ARCHITECTURAL REVIEW BOARD MEETING
CITY HALL, 385 SOUTH GOLIAD STREET, ROCKWALL, TEXAS
JULY 29, 2025 IN THE CITY COUNCIL CONFERENCE ROOM AT 5:00 PM

PROJECT COMMENTS

PROJECT NUMBER: SP2025-032
PROJECT NAME: Site Plan for 855 Whitmore Drive
SITE ADDRESS/LOCATIONS: 855 WHITMORE DR

SITE PLAN

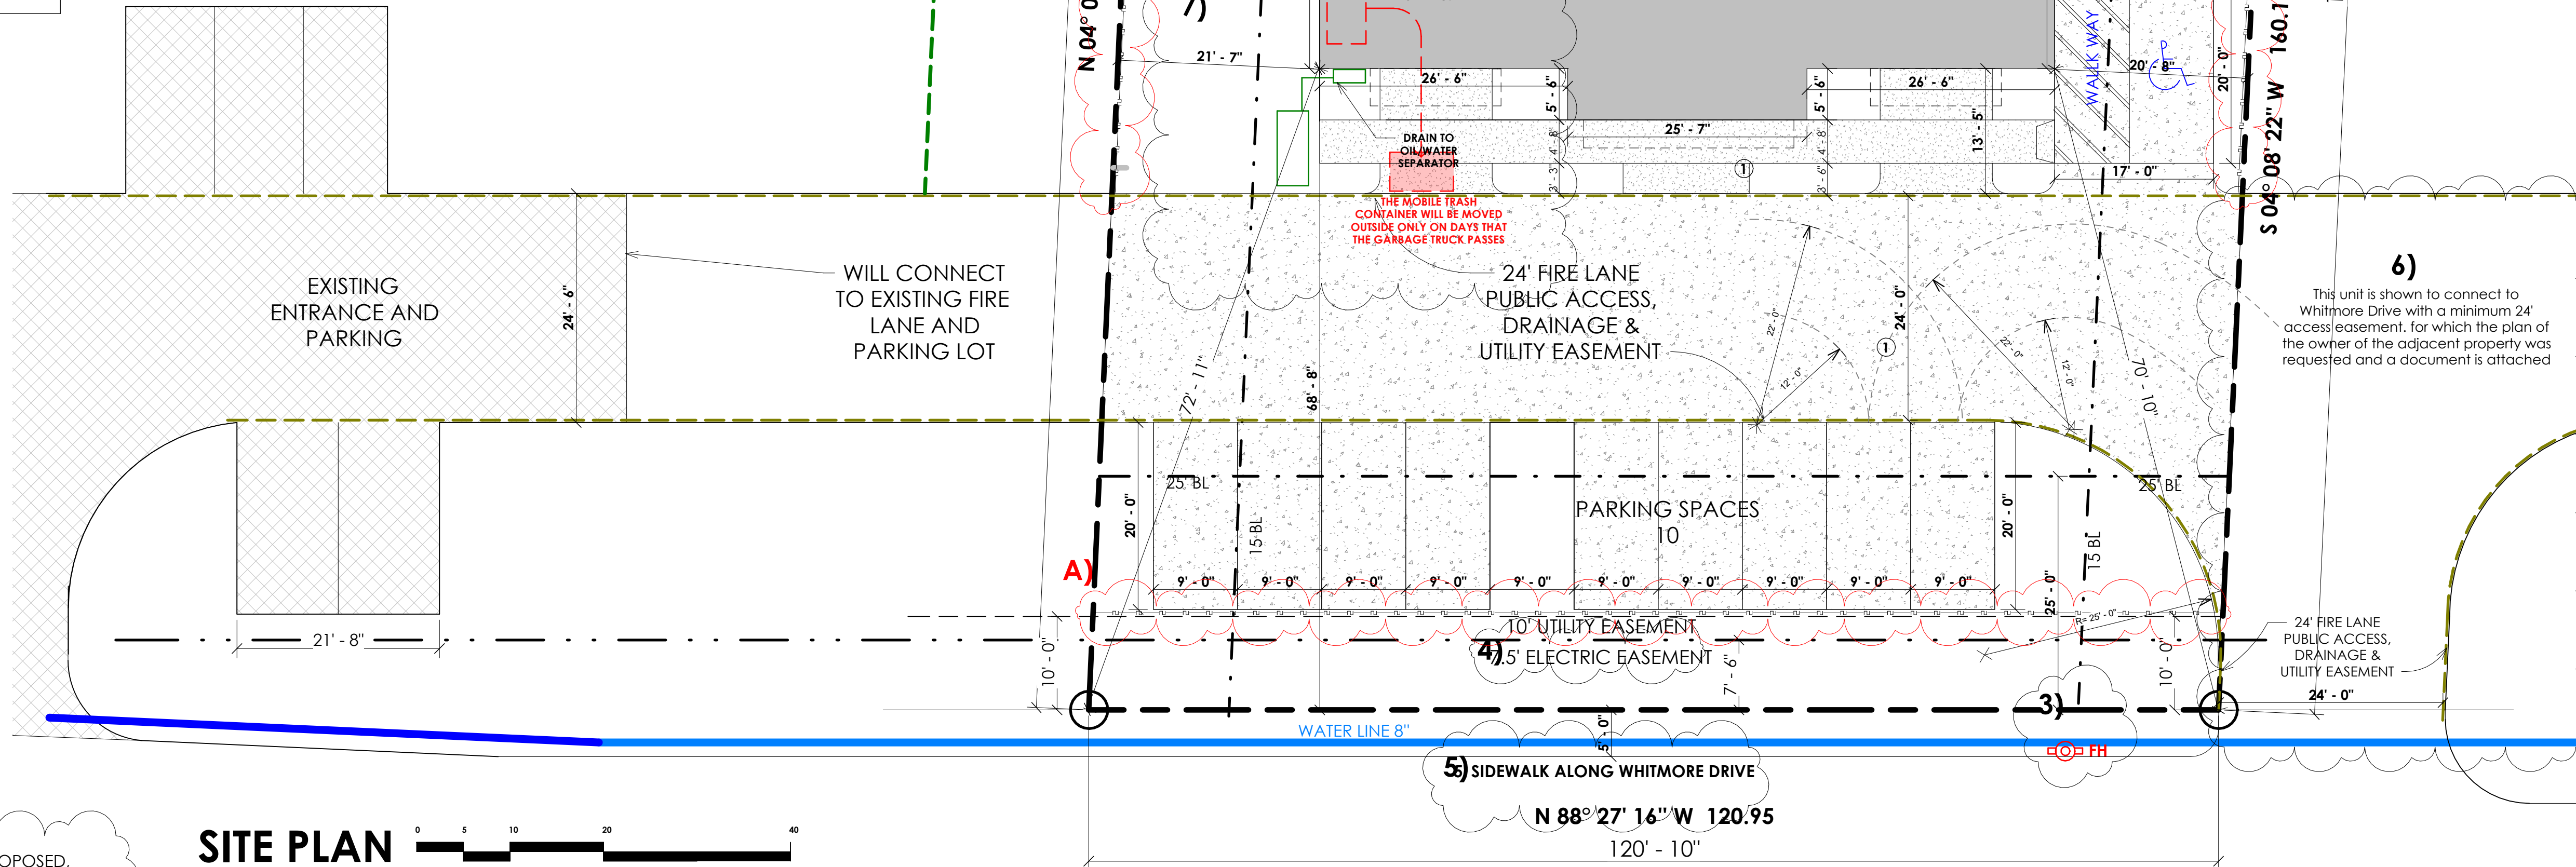
M.6 Site Plan.

- (1) Please include the Owner and Developer information (i.e. name, address, and phone number). (Subsection 03.04. B, of Article 11, UDC)
- (2) Please indicate the adjacent street right-of-way. (Subsection 03.04. B, of Article 11, UDC)
- (3) Please provide a parking table that details the required parking per use. Office is 1 space per 300 SF and Manufacturing is 1 space per 500 SF. (Subsection 05.01, of Article 06,

- (4) Please indicate the type and depth of the paving material and provide a detail or cut-sheet. All required parking and loading areas shall be constructed of concrete, but may have a surface treatment of brick, stone or other similar material. (Subsection 03.02, of Article 06, UDC)

- (5) Signage is done through separate permits with the Building Inspections Department. (Subsection 06.02. F, of Article 05, UDC)
- (6) Please indicate if there will be gates. If so, please provide a detail. All fences must be constructed as a masonry wall, or be wrought iron. A picket metal fence is not permitted. In addition, please remove the note indicating that no fence is proposed. (Subsection 08.02. F, of Article 08, UDC)

- (7) Off-street loading docks must be screened from all public streets and any residential district that abuts or is directly across a public street or alley from the lot. The screening must be at least six feet in height and may be provided by using a masonry fence, berms, plantings or a combination of the above. In this case, the bay doors face directly onto Whitmore Drive and cannot be screened. Given this, this will require an exception from the Planning and Zoning Commission. Staff should note, this exception is one reason this case was denied previously. (Subsection 01.05. A, of Article 05, UDC)

07/25/2025: * Will there be a fence or not - plans state there won't be a fence but plans also indicate fencing that is clouded. - Separate fence permit from the building plans is required

FRONT ELEVATION

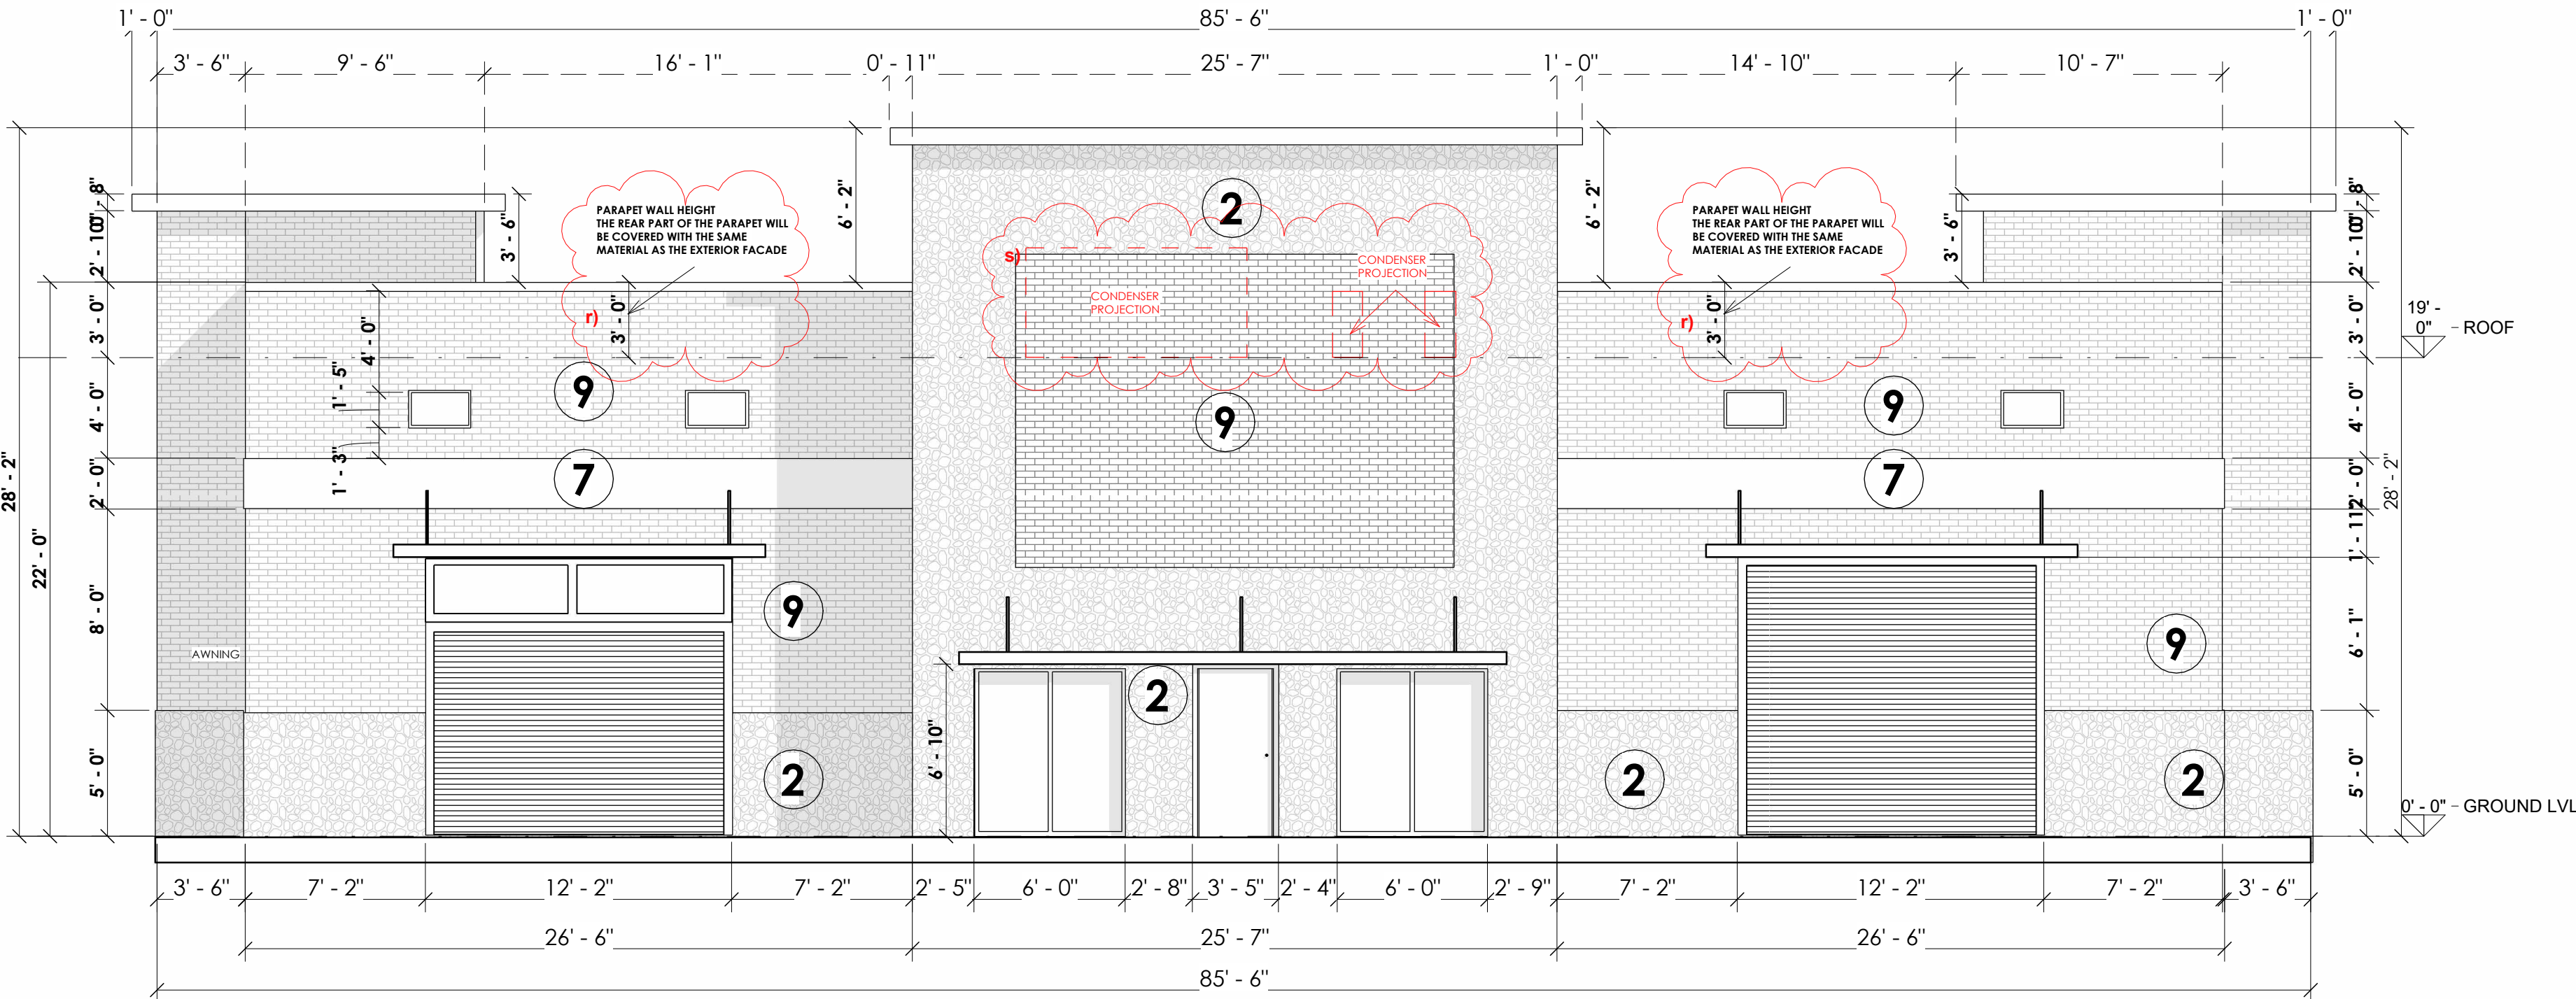
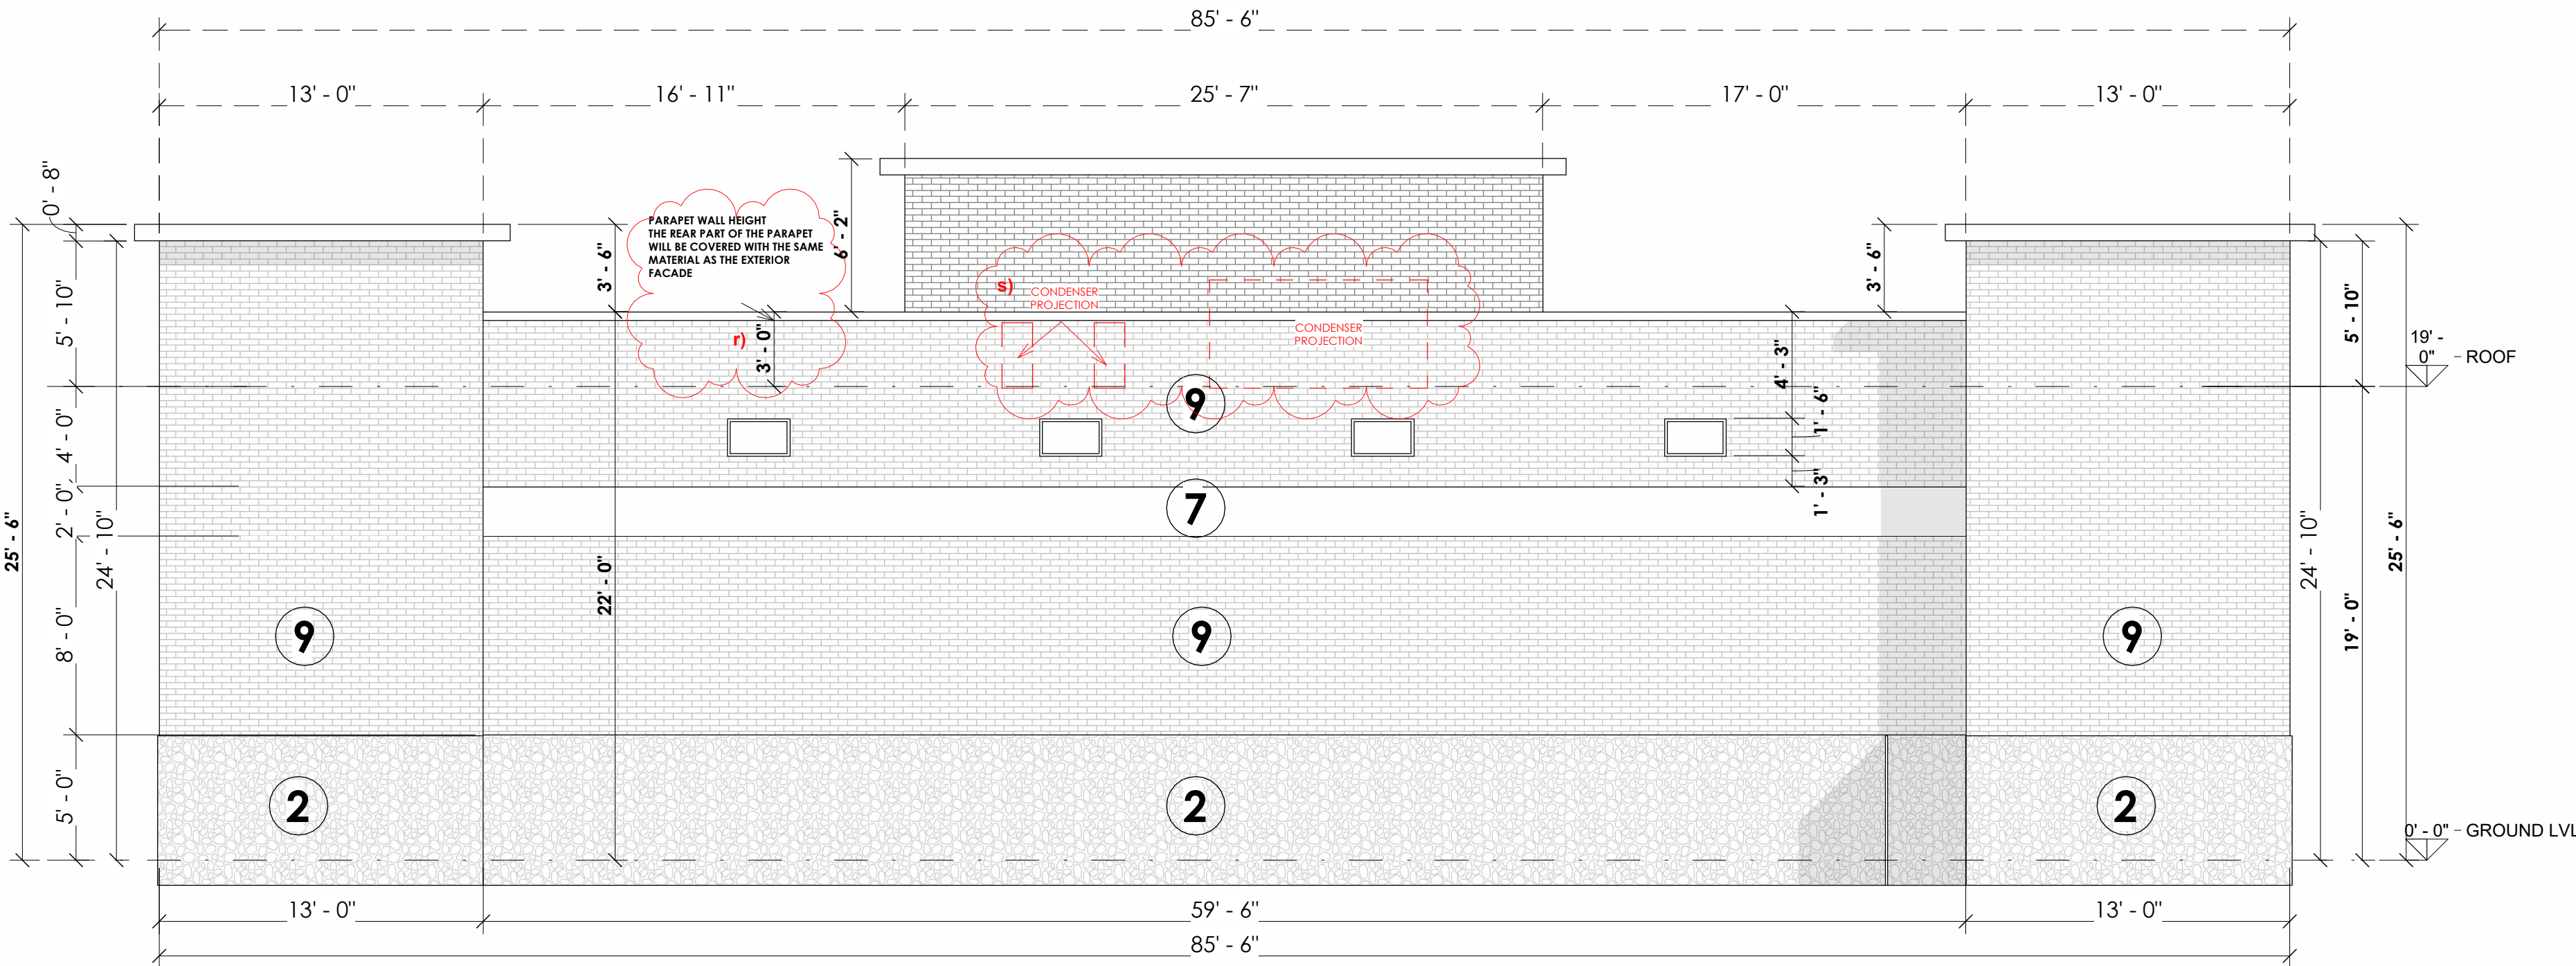
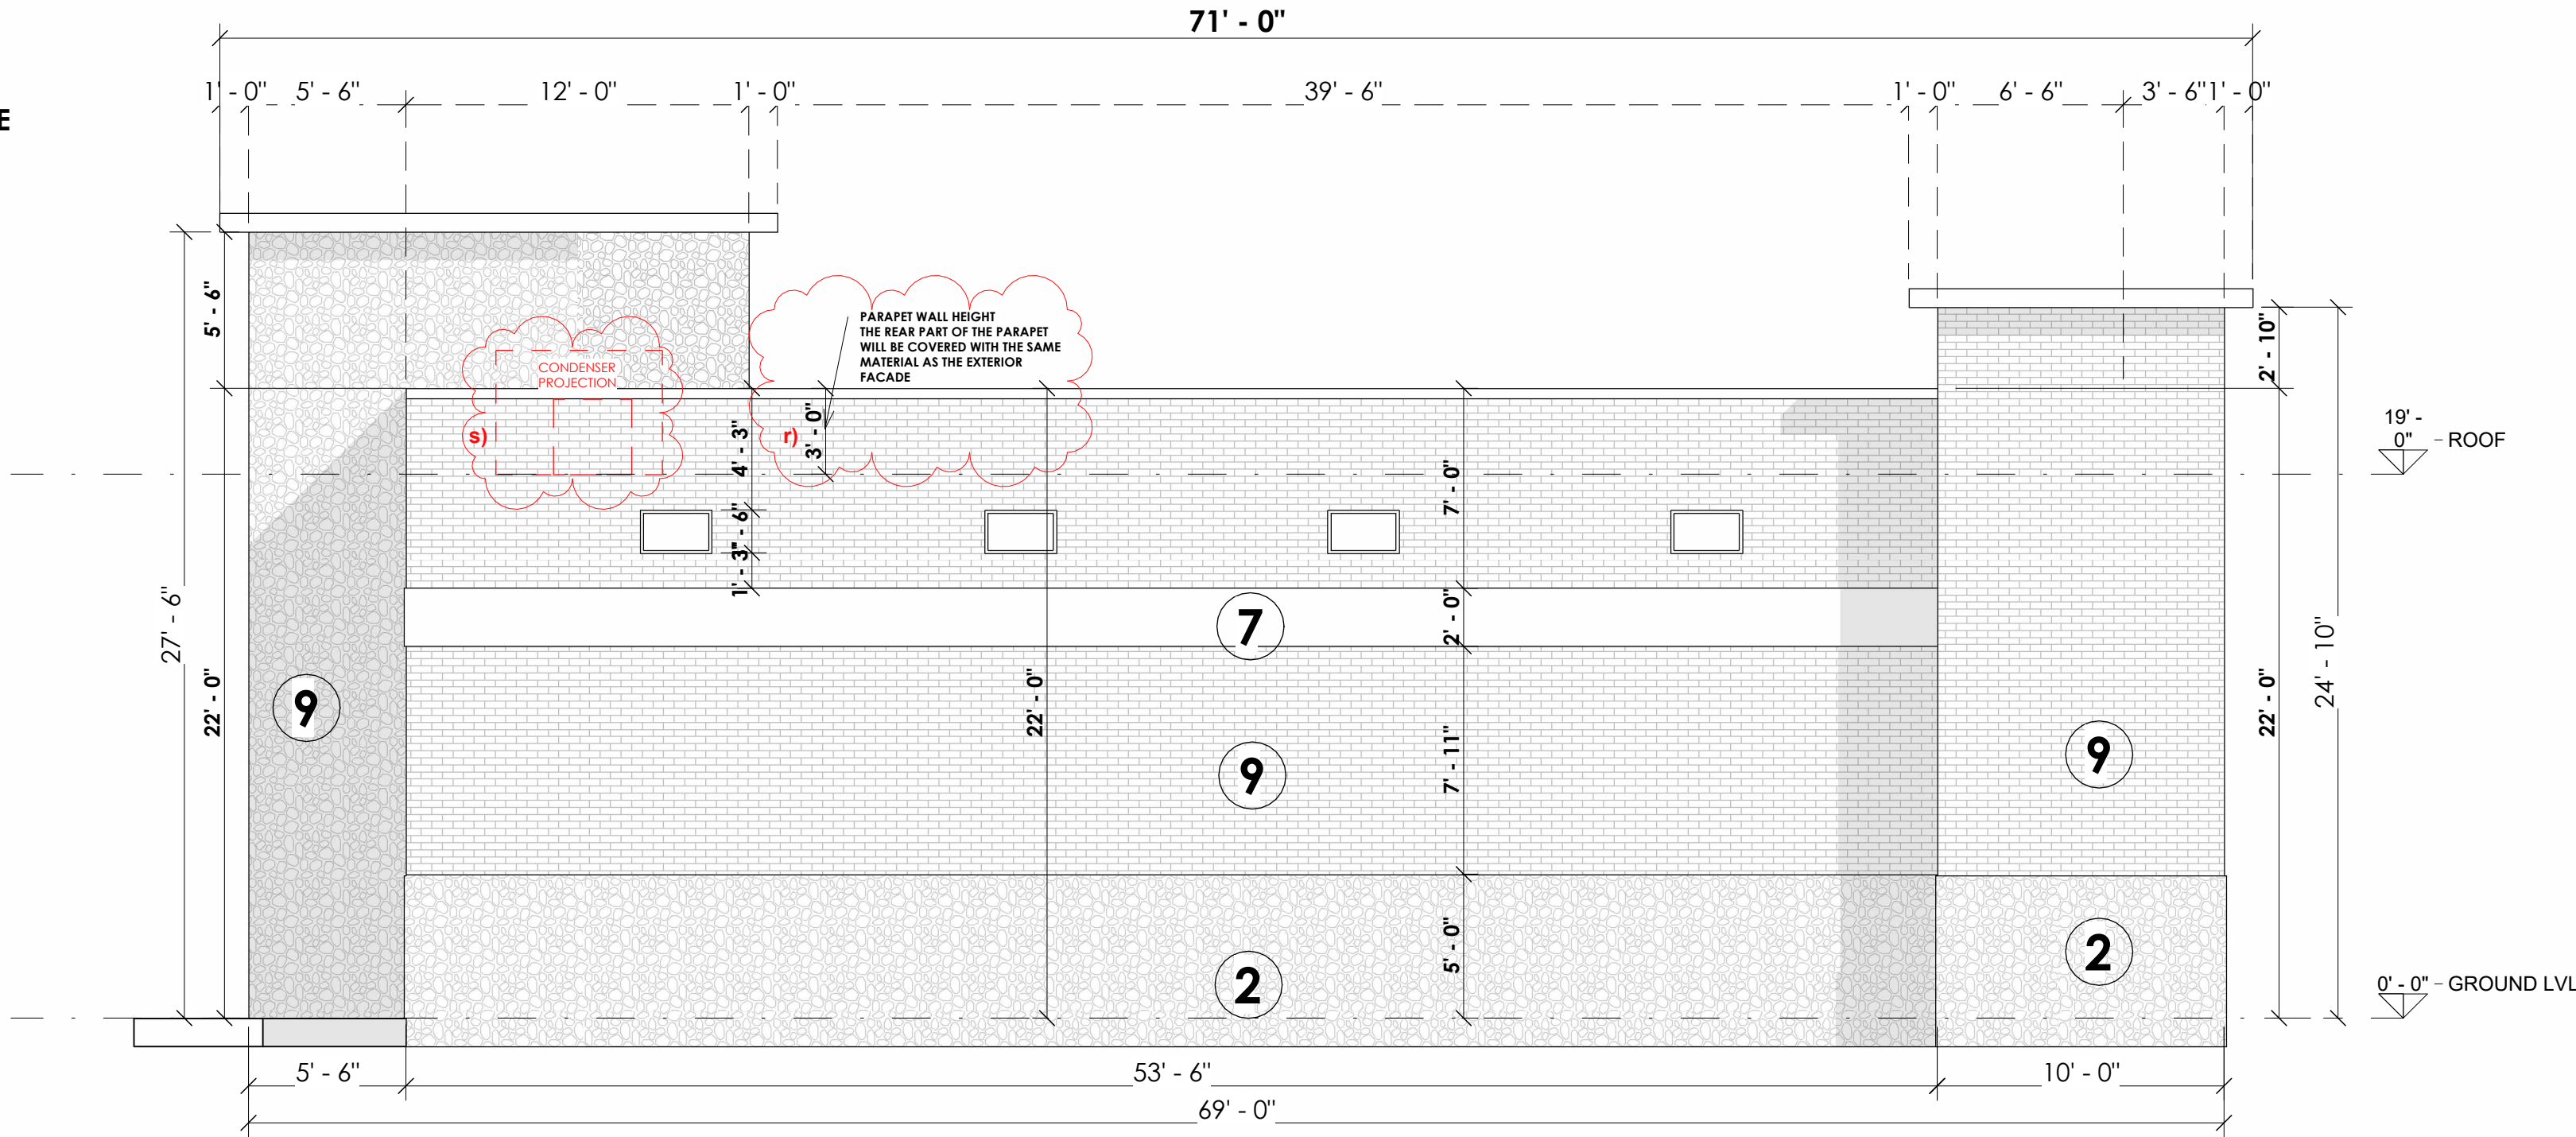
M.10 Building Elevations

- (1) Please delineate and label the scuppers and downspouts. (Subsection 05.01. of Article 05, UDC)
- (2) All RTUs must be fully screened by the parapet. In this case, the RTUs extend above the parapet wall. (Subsection 01.05. C, of Article 05, UDC)
